5. Grouse Creek Subdivision 2024 Addition KPB File 2022-022R2 Johnson Surveying / Marshall & Esther Ronne Living Trust Location: Punkin Avenue & Seward Highway Bear Creek Area Vicinity Map

# ITEM 5 - PRELIMINARY PLAT GROUSE CREEK SUBDIVISION 2024 ADDITION

KPB File No.	2022-022R2
Plat Committee Meeting:	October 14, 2024
Applicant / Owner:	Marshall & Ester Ronne Living Trust
Surveyor:	Jerry Johnson / Johnson Surveying
General Location:	Mile 7 Seward Highway, Bear Creek Area

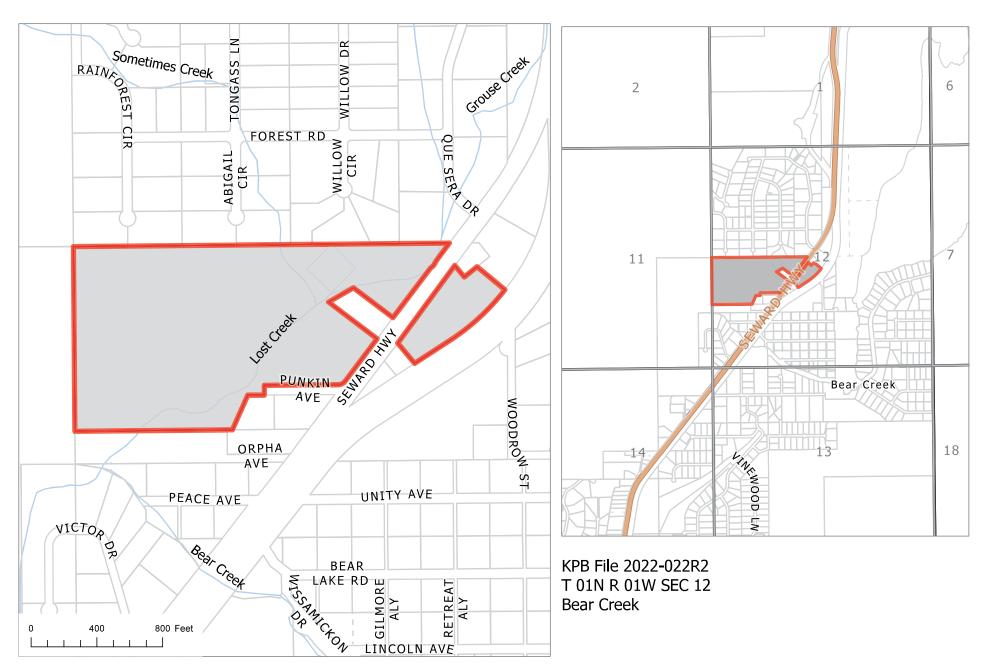
Add portion of subdivision east of highway to the vicinity map

Correct spelling of Kwechak Creek.

Show location of Chugach National Forest more definitively on the map.

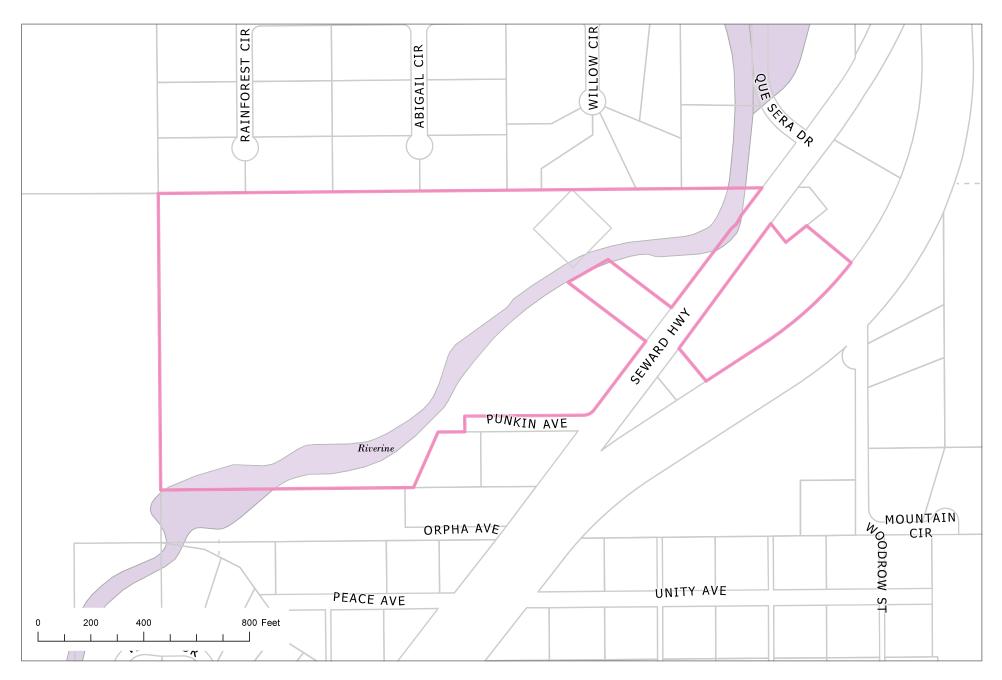
The certificate to plat notes a section line easement, possibly located on the west line. **Staff recommends** that the surveyor verify the section line easement and, if necessary, add it to the drawing.

There is an access easement granted for the one-acre lot excluded from the plat within Tract B1. This access easement is noted in plat note #10. **Staff recommends** correcting plat note #10 to match the parent plat note by changing "road" to "driveway."

There are structures located on the plat that will be split between the lots B2 and B3 and Tract B1.

The low wet areas are depicted on the plat. The correct plat note is present that a wetlands determination may be required.

The proposed subdivision is within a flood hazard area. The flood hazards are depicted and labeled on the plat and should remain on the final plat.

Plat notes are present on the plat. Flood Hazard and Floodway notices are present as notes 5 and 6. The Seward Bear Creek Flood Service Area had requested additional wording to the flood hazard note or a new note be added when they reviewed the first design. Staff recommends adding to the flood hazard notice or adding an additional note, "Portions of the parcel are also designated as Seward Mapped Flood Data Area as included in the Flood Risk Assessment and Hydrologic and Hydraulic Report."

According to the parent plat Grouse Creek Subdivision 2016 Addition SW 2016-7, there is a drive encroachment near proposed Lot B4 crossing into Lot 3. Staff recommends the surveyor identify if this driveway is still encroaching and if so, show on the final and present staff with a solution. And note any other issues.

An additional easement was granted by document for existing lines. Per the attachment recorded with the easement, this easement runs through portions of Tract B1 to the Deed lot. The plat is depicting some overhead lines within the proposed dedication and within portions of Tract B1. **Staff recommends** the depiction of the easement as granted be shown on the plat with a reference to the recording document or provide a plat note.

Carry forward plat note #11 from the parent plat SW 2016-7. Give dimensions for line between lots B3 and B4, north of road.

Add to the legal WD Bk 23D Pg 133

Add to the legal behind Grouse Creek Subd. No. 2 SW98-16

Correct the legal to the N1/2 SW1/4 Section 12 on line 3.

Under Prepared for; correct to Marshall & Esther Ronne Living Trust, dated May 15, 2002

Verify if there is and size of a section line easement on the west line of the plat and if so, show it on the plat.

10' proposed utility easement should match the existing 15' utility easement from parent plat.

Lots should be relabeled to numbers without the B and be consistent with the lots to the east.
